SPIRE-RAL-NOT-001400

## Spire CVV Connectors

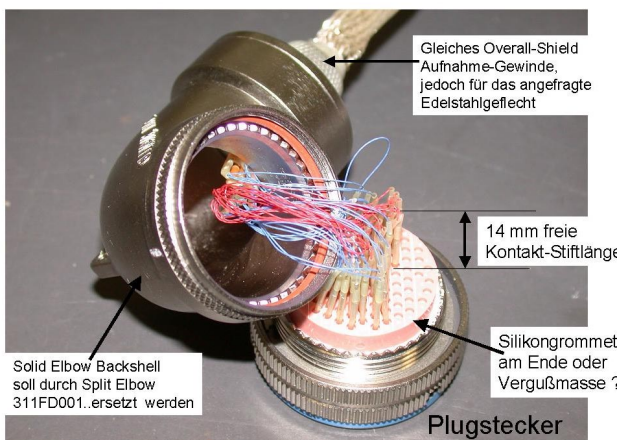
The SPIRE SIH and the SPIRE Test cryostat-harness has been designed by use of 128 contact connectors.

When we reviewed the IIDB issue 1.0 dd: 31.07.01 related SPIRE Harness lists ref. SPIRE-RAL-PRJ-000608, we detect, that man need 156 contacts to be wired under condition of the Cryostat EQM / PFM conditions, see also HP-2-ASED-MN-0112\_SPIRE\_180402, where up to 10 shield-jumper wires have to be connected on 1 contact. [For our design we split afterwards each "alias 128 pol. connector" into 2 connectors accordingly, to cover also the Alcatel spare philosophy requirements.]

backshell4.jpg

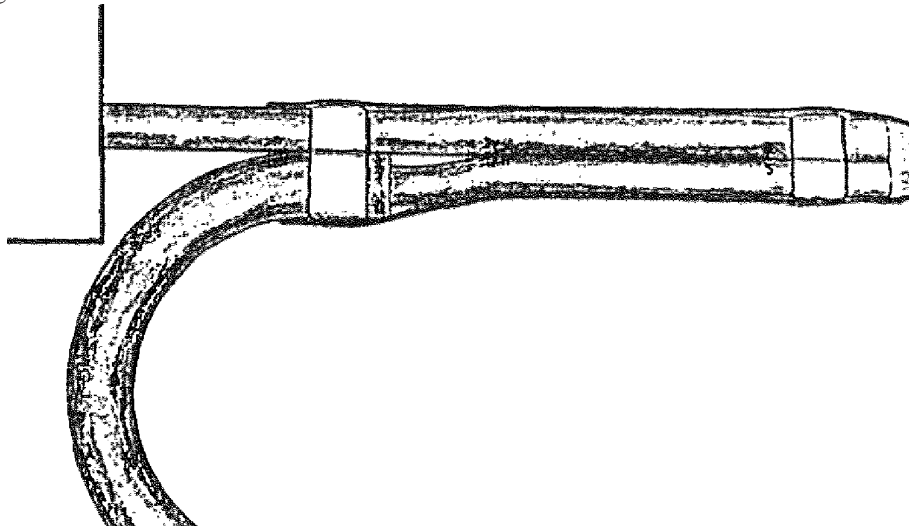
The ISO design foresees that all harness cables are routed from side (90°) towards the connector contacts. The single wires are routed through the solid-wire spills and will be bend by 90° in direction to and close to the contact rear-side end, where they will be soldered.

The contact pitches are small and will be eaten very soon by all the solid wires passing in between, + the needed individual protection sleeves around each solid wire contact + the bigger diameter at the contact-end , covering the soldered SST wire + the wire-pin interconnection by use of a "tube / wrapped coil" around each single contact

backshell1.jpg

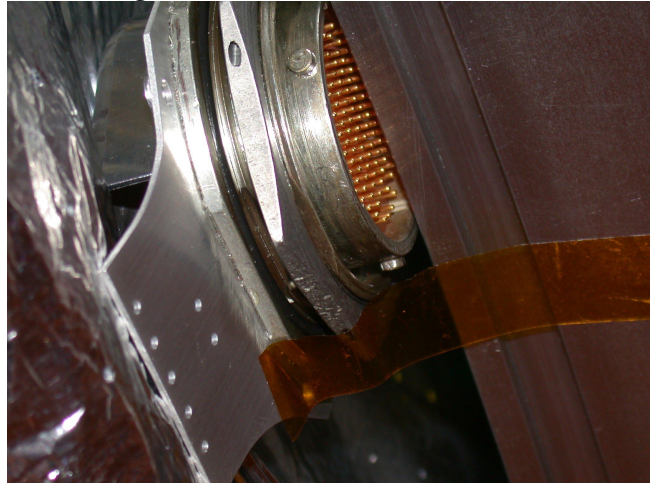
Such kind of interconnection ring, we tried first to design, but we failed w.r.t. the unavailable space and the possibility to fix such a "shield-ring" when the harness wires have to be routed from the side through the ring first would have to be and afterwards all the welded shield-jumper leads have to be fold back and soldered to the ring. The shield-ring should not have any contact to the "integration protection-cap", which is mounted rearside on the feedthrough connector flange.(see backshell 1.jpg + backshell6.jpg, to fit harness to upper connector ring, the integration protection cap is need)
